## IMPORTANT SAFETY RECALL NOTICE

Your Electric Door Opener PC Board is being recalled

## TECHNICAL BULLETIN DOC00039

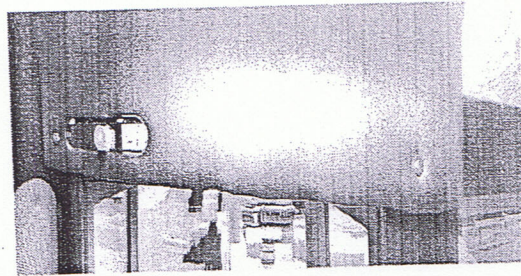
It has come to our attention that a safety recall on the swing door module (model 3230 PC Board). It has the potential of overheating and causing a short circuit. This module is located on your door header of your swing doors (see attached pic). We are notifying all bus owners that have the possibility of having this issue. See attached for procedures on how to identify and get a replacement module. This recall applies to Tiffany E450 and F550 limo/shuttle busses only.

(Remove header cover, some are vinyl some carpet)

*Screws are up 2" from bottom  
2" in from left and 4" in from*

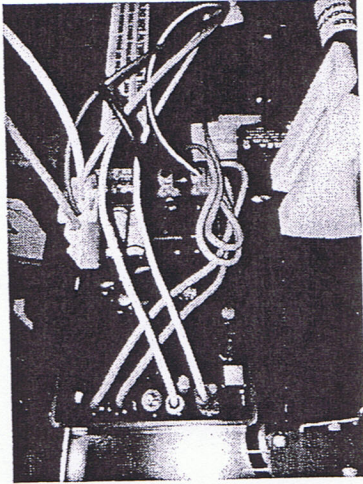
(Module is held down with double sided tape)

*Module is held in place by double side tape.*

How to Identify the 3230 PC Board

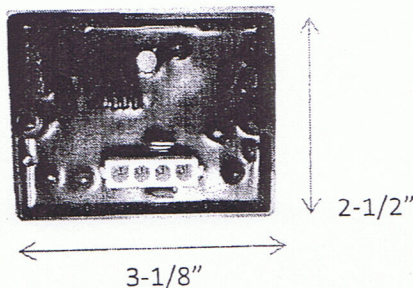
We are aware of one model of PC Board with the potential of over-heating. This PC Board (Model 3230) was supplied to and installed on certain A&M Systems Door Headers manufactured from August 1, 2009 through March 31, 2010. Additionally, PC Boards that were field replaced during this time period could be affected and will need to be inspected. While these reports are few, the over-heating situation could cause the PC Board to burn in extreme cases. As a result we are sending this Technical Service Bulletin to help you identify and replace this PC Board.

1. The Model Number of the PC Board is located on the Information label that is on the outside edge of the tray.

2. The physical size of the 3230 PC Board Tray is 3 1/8" x 2 1/2". All other PC Board models used by A&M Systems have larger trays.

1. Remove PC board from Header – PC Board is attached to Header plate with double face tape.
  - a. Unplug the four-pin connector feeding the board.
  - b. Unplug the blue wires from the open limit switch.
  - c. Remove the board by twisting and pulling the board off the header plate.
2. Remove the Information Label from the 3230 Model PC Board showing the 3230 Model number on the label.
3. Record the following from the removed PC Board:
  - a. The scribed information from the outside edge of the board \_\_\_\_\_.
  - b. Header Model \_\_\_\_\_.
  - c. Header S/N \_\_\_\_\_.
  - d. Vehicle VIN \_\_\_\_\_.
4. Cut the two blue wires near the base and using the pre-addressed, postage paid enclosed envelope, send the label, the clipped wire harness and this form to:

5. Replace the existing fuse powering the PC Board with a 20 amp fuse.
